Going-to-the-Sun Road
Identified Roadway Deficiencies - 2001

Going-to-the-Sun Road
Identified Roadway Deficiencies - 2001
Alpine Section
Alder Creek Segment - Map 1 of 3
Guard Walls:
ashlar stone
concrete-core
jersey barrier
removable rail
random rubble stone
mixed stone
Retaining Walls:
concrete
stone
Other Linear Features:
barrier rock
curb
post and rail fence
CMP culvert with stone headwall
concrete-box cross-road drains with metal grate inlet
CMP culvert
CMP culvert with stone headwall
CMP culvert with modern drop box inlet
CMP culvert with stone headwall
CMP culvert with stone headwall
drop inlet covered with boards
FHWA wall 25.01
FHWA wall 25.29
FHWA wall 25.32
FHWA wall 25.33
FHWA wall 25.34
FHWA wall 25.36
FHWA wall 22.82
pullout
pullout
pullout
MP 23.0
MP 23.1
MP 25.3
MP 25.4
MP 25.5
MP 25.6
MP 25.7
919
917
916
915
914
913
912
911
910
909
908
906
905
904
903
MP 25.3 - 25.5:

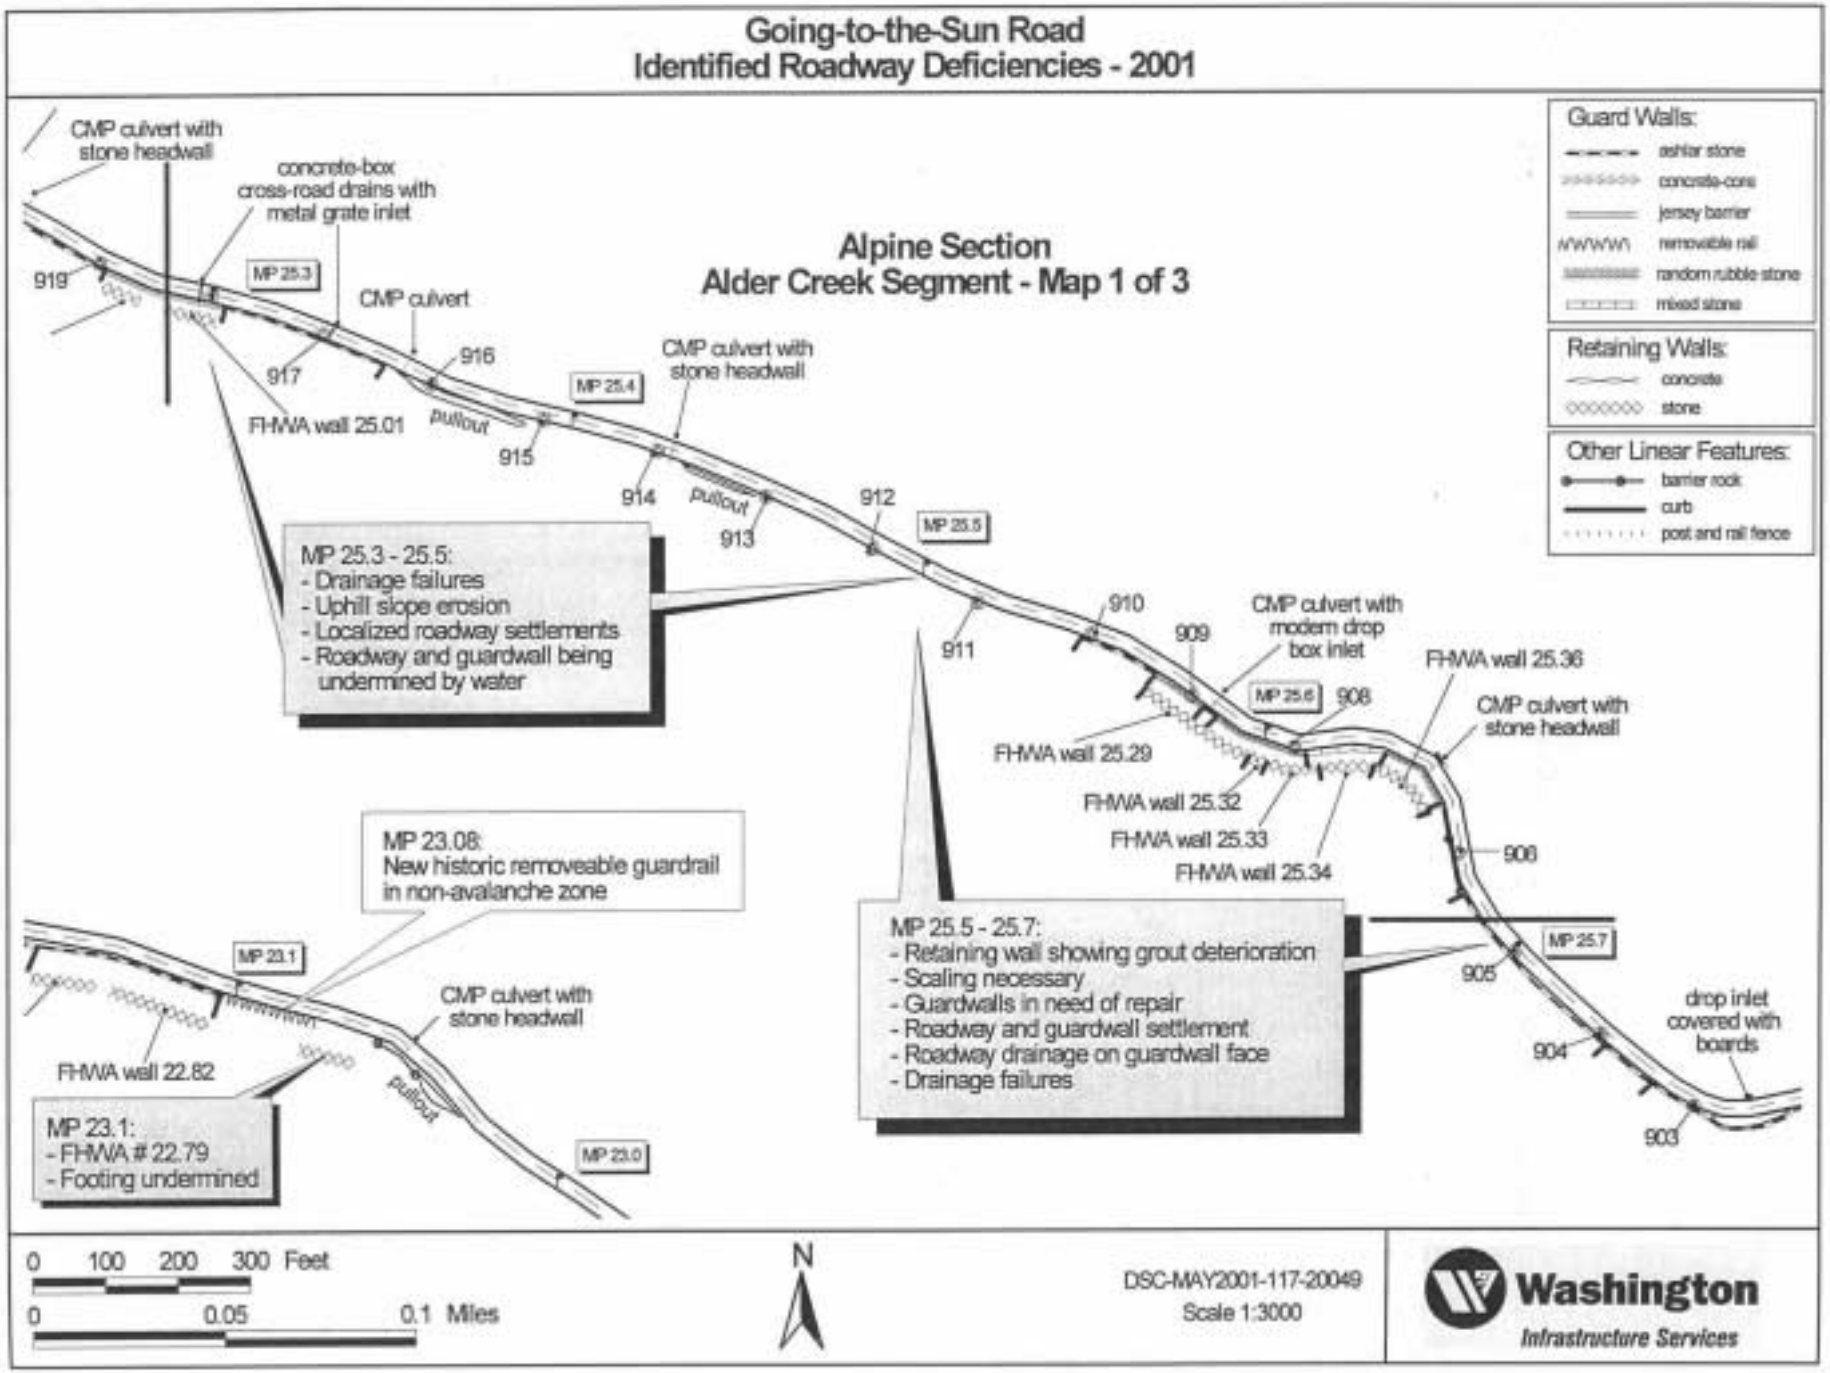
- Drainage failures
- Uphill slope erosion
- Localized roadway settlements
- Roadway and guardwall being undermined by water
MP 23.08:
New historic removeable guardrail in non-avalanche zone
MP 25.5 - 25.7:

- Retaining wall showing grout deterioration
- Scaling necessary
- Guardwalls in need of repair
- Roadway and guardwall settlement
- Roadway drainage on guardwall face

- Drainage failures
MP 23.1:
- FHWA # 22.79
- Footing undermined
0 100 200 300 Feet
0 0.05 0.1 Miles
N
DSC-MAY2001-117-20049
Scale 1:3000
Washington
Infrastructure Services

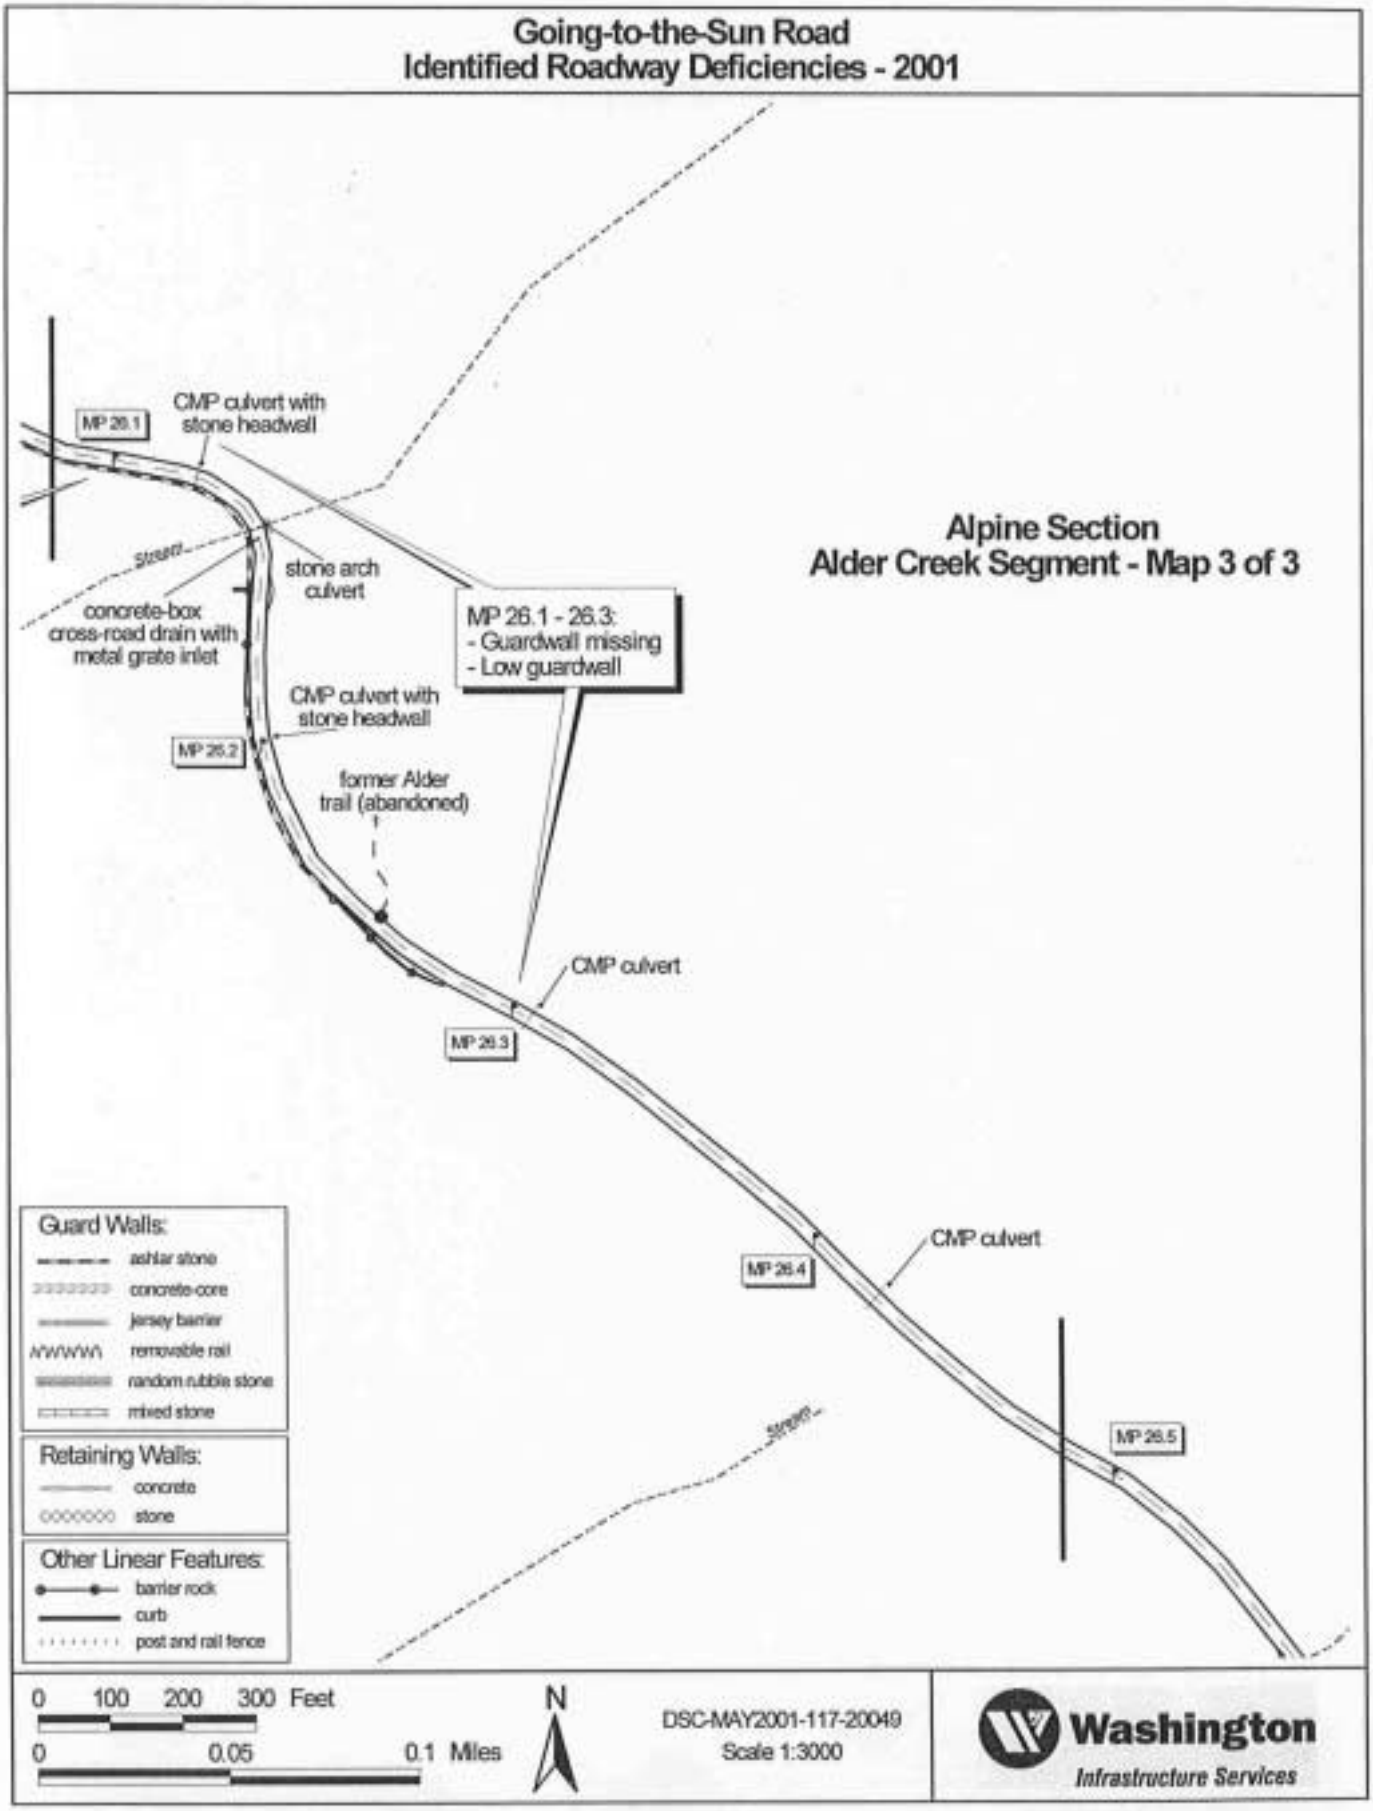
Going-to-the-Sun Road
Identified Roadway Deficiencies - 2001
Alpine Section
Alder Creek Segment - Map 3 of 3
MP 26.1
CMP culvert with stone headwall
stream
stone arch culvert
concrete-box cross-road drain with metal grate inlet
MP 26.1 - 26.3:
- Guardwall missing
- Low guardwall
CMP culvert with stone headwall
MP 26.2
former Alder trail (abandoned)
CMP culvert
MP 26.3
CMP culvert
MP 26.4
MP 26.5
stream
Guard Walls:
ashlar stone
concrete-core
jersey barrier
removable rail
random rubble stone
mixed stone
Retaining Walls:
concrete
stone
Other Linear Features:
barrier rock
curb
post and rail fence
0 100 200 300 Feet
0 0.05 0.1 Miles
N
DSC-MAY2001-117-20049
Scale 1:3000
Washington
Infrastructure Services

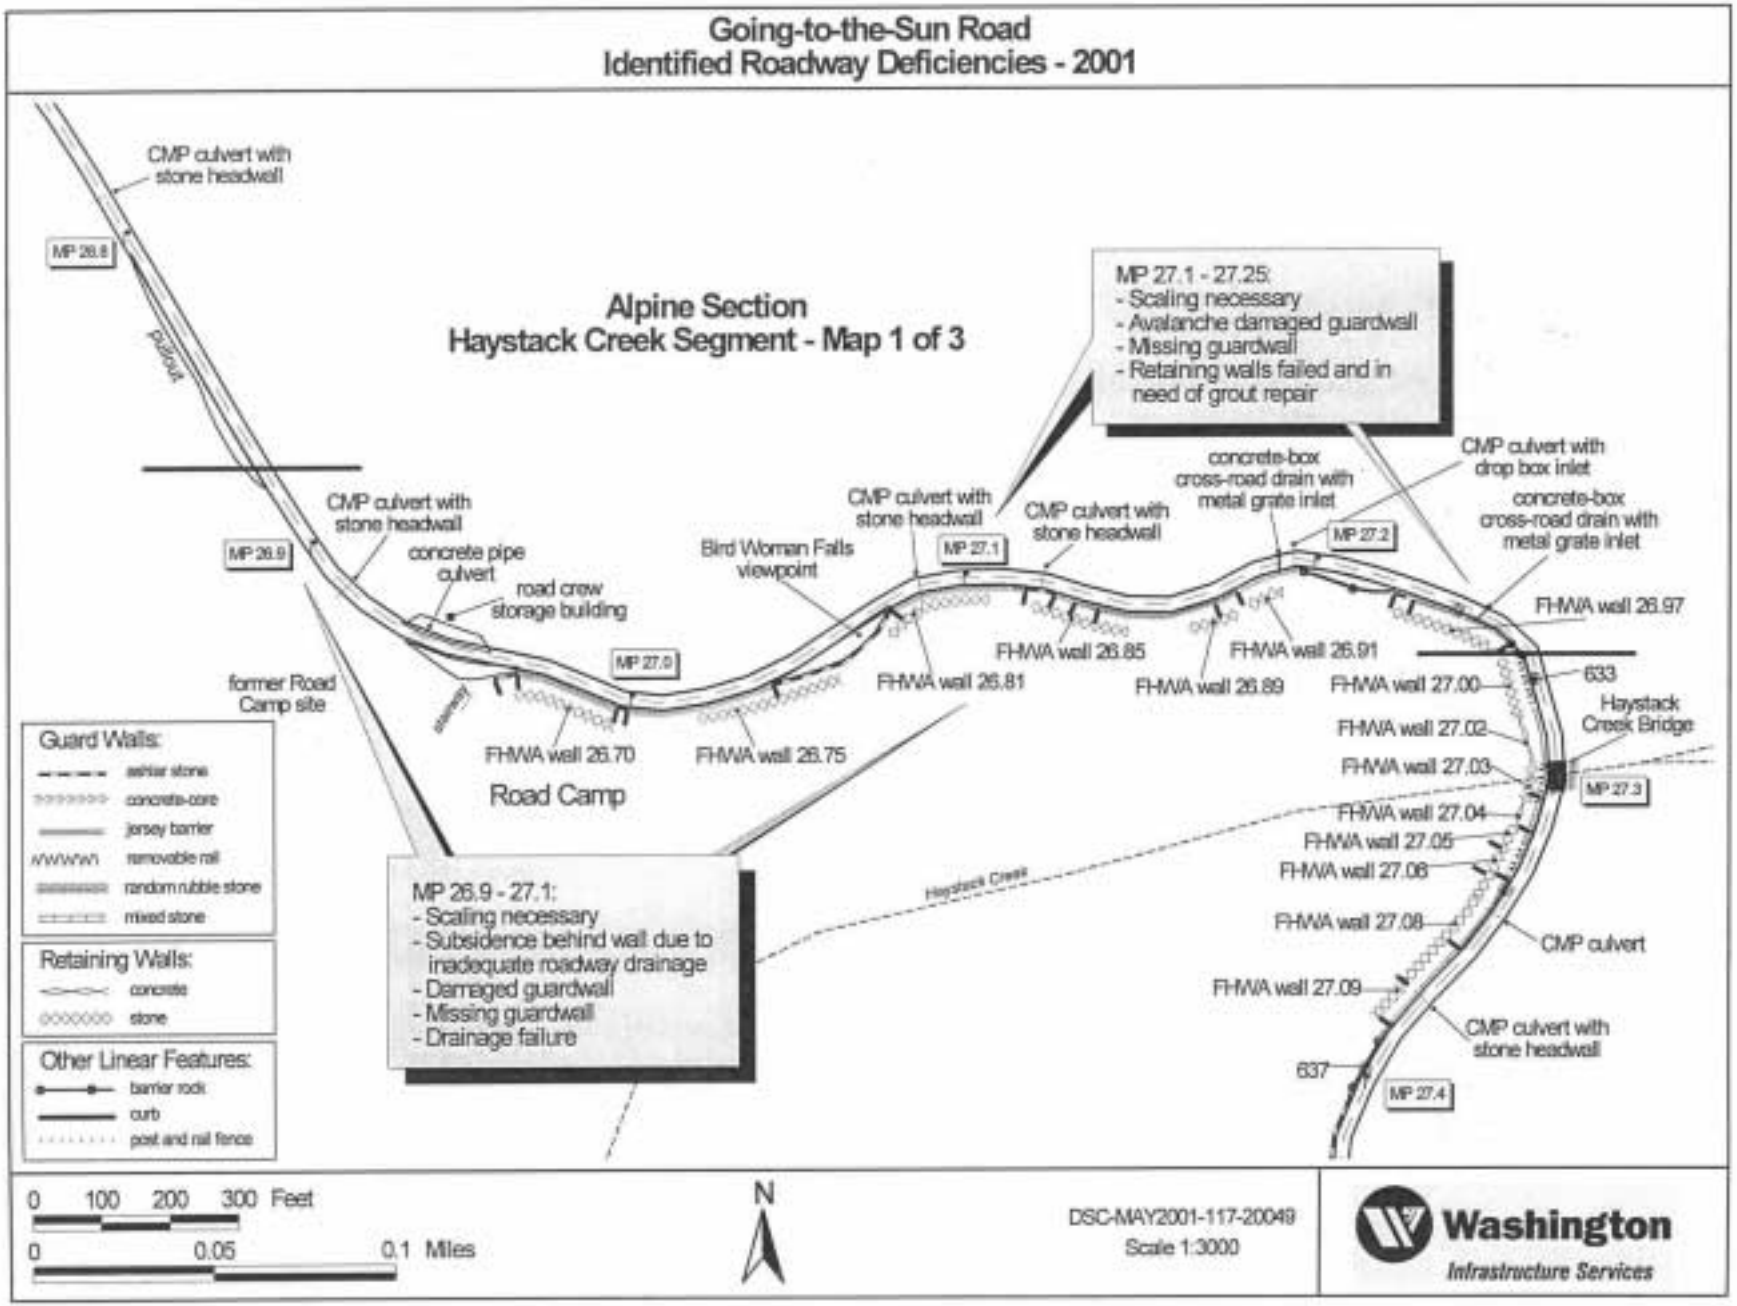
- Scaling necessary
- Avalanche damaged guardwall
- Missing guardwall
- Retaining walls failed and in need of grout repair
MP 26.9 - 27.1:
- Scaling necessary

- Subsidence behind wall due to inadequate roadway drainage
- Damaged guardwall
- Missing guardwall
- Drainage failure
Guard Walls:
ashlar stone
concrete-core
jersey barrier
removable rail
random rubble stone
mixed stone
Retaining Walls:
concrete
stone
Other Linear Features:
barrier rock
curb
post and rail fence
0 100 200 300 Feet
0 0.05 0.1 Miles
N
DSC-MAY2001-117-20049
Scale 1:3000
Washington
Infrastructure Services

- Damaged guardwall
- Several removeable guardrails need replaced
- Concrete wall without stone veneer
- Drainage failures
- Guardwall and retaining walls showing subsidence problems
Alpine Section
Haystack Creek Section - Map 2 of 3
639
MP 27.5
CMP culvert with stone headwall
641
MP 27.45 - 27.65:

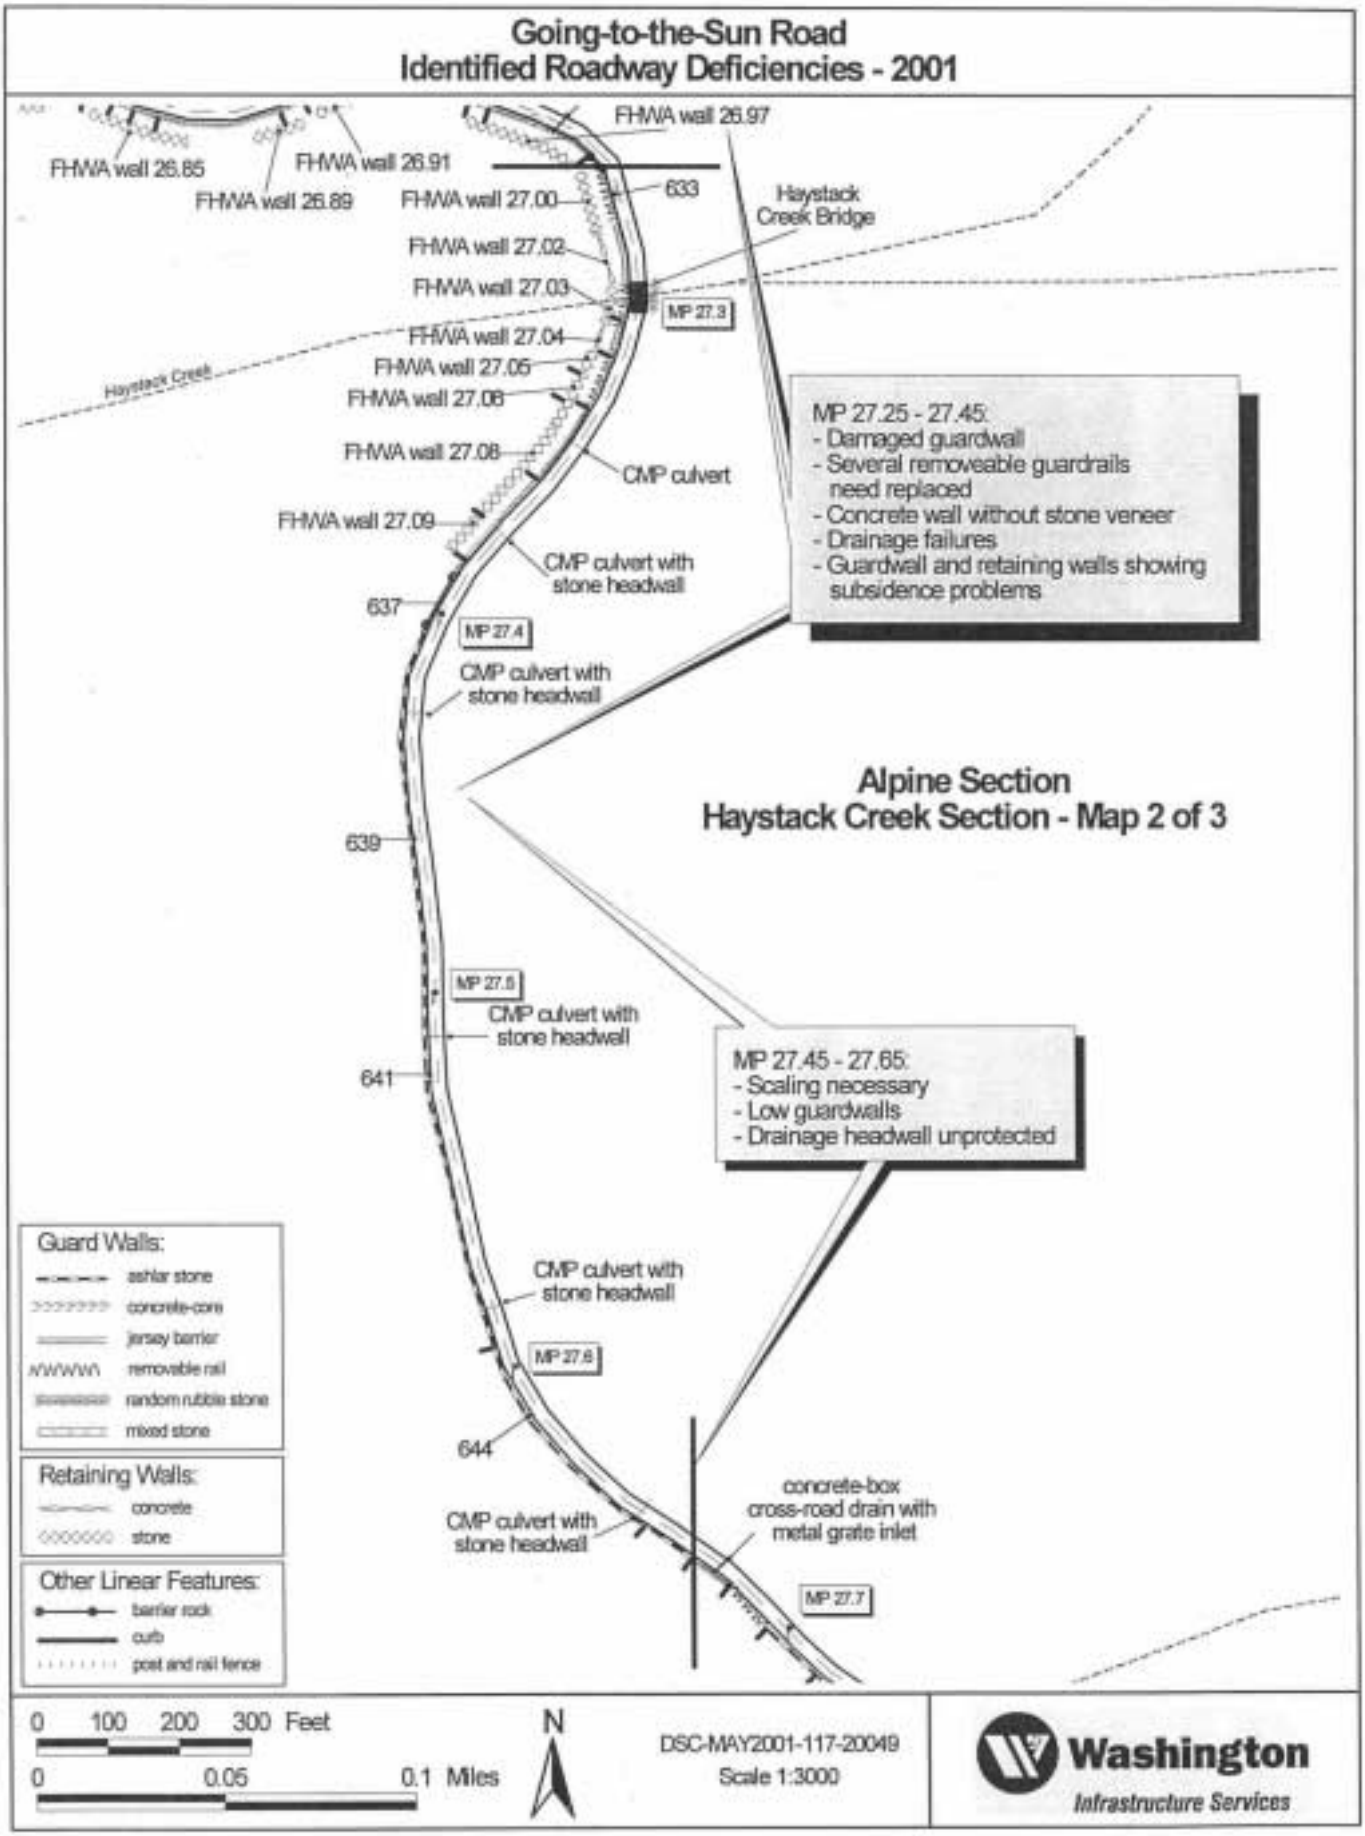
- Scaling necessary
- Low guardwalls
- Drainage headwall unprotected
CMP culvert with stone headwall
MP 27.6
644
concrete-box cross-road drain with metal grate inlet
CMP culvert with stone headwall
MP 27.7
Guard Walls:
ashlar stone
concrete-core
jersey barrier
removable rail
random rubble stone
mixed stone
Retaining Walls:
concrete
stone
Other Linear Features:
barrier rock
curb
post and rail fence
0 100 200 300 Feet
0 0.05 0.1 Miles
N
DSC-MAY2001-117-20049
Scale 1:3000
Washington
Infrastructure Services
